802.3dj D1.1

Comment Resolution

Electrical Topics

Adee Ran (Cisco), 802.3dj Electrical Lead Editor
<others>

C2M ILdd budget and host model

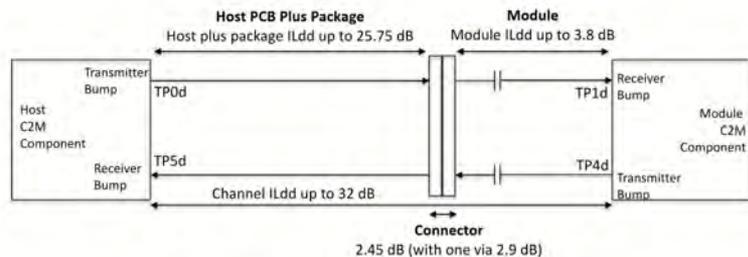
CI 176E SC 176E.5.2 P703 L41 # 422
Ran, Adee Cisco Systems, Inc.
Comment Type TR Comment Status D C2M Host channel

CI 176E SC 176E.2 P695 L40 # 115
Ghiasi, Ali Ghiasi Quantum/Marvell
Comment Type TR Comment Status D k diagram, C2M Host channel
Figure TBDs
SuggestedRemedy
See Ghiasi_01 supporting presentation from July-24
Connector Ildd=2.45 dB
Module Ildd=3.8 dB
Host Ildd=23.75 dB

- Adopt 34 dB as the reference max ILdd between TP0d and TP1a.
- Adopt the COM channel model parameters of "option 2" on slide 16 of ran_3dj_01b_2407 . Use these parameters for the host PCB model for C2M in Table 176E-5. Delete the "Class A package model" row and set "Transmission line 1 length" in the "Class B package model" row to 45 mm (one value).

- In Table 176E-9, change TBDs in "Test channel insertion loss at 53.125 GHz" row (module test) to: Low loss: min=9 dB, max:10 dB (a mated test fixture), High loss: min=33.5 dB, max=34.5 dB (reference TP0d-TP1a loss +/- 0.5 dB)

Creating C2M module specifications (cont)

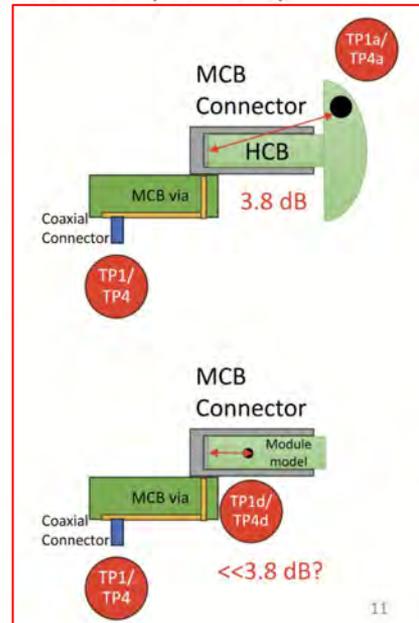
- Even if we had a reference model for the module... deriving input/output specifications is more complicated than the host case
- We need reference models of the TP1-TP1d and TP4d-TP4 channels
 - These are shorter than TP1-TP1a and TP4a-TP4 in a mated test fixture
 - We can't start with measured MTF S-parameters and add some mathematical model, as in the host case...
- Contributions in this area are encouraged
 - Mathematical expressions
 - Explicit S-parameters
 - Combinations
 - Other ideas

With an allocation of 3.8 dB to the HCB, The insertion loss between TP1d and TP1a is likely about 3 dB (it may be lower if the DSP in the module is packaged).

C2C Channel Comment 33

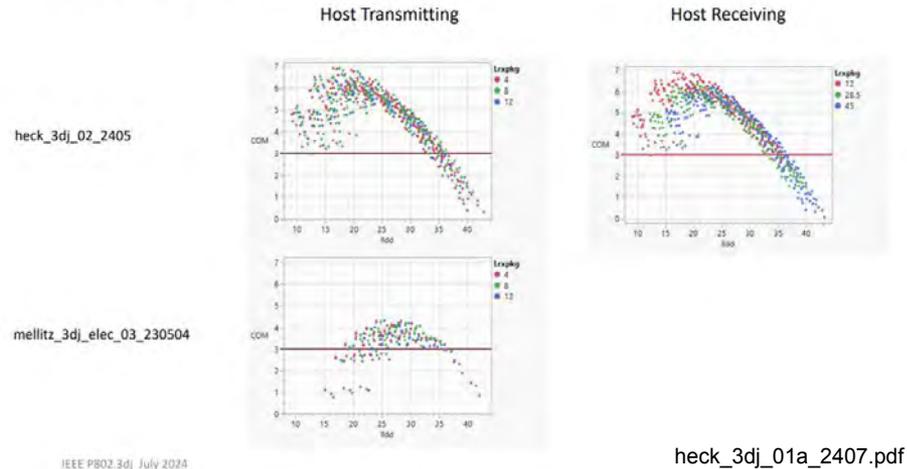
Comment Type T Comment Status D C2C channel

Replace "TBD" with "30 cm"

The comment proposes to replace a the TBD for approximate interconnect length. The referenced contribution, [heck_3dj_01a_2407](#), contains COM results as a function of die-die insertion loss, but not PCB length.

PROPOSED REJECT.

The contribution referenced in the comment does not mention interconnect length, so it does not justify the suggested remedy.

Editors' recommendation: change "with electrical interconnect of approximately TBD cm in length" to "with electrical interconnect of up to approximately 30 cm in length".
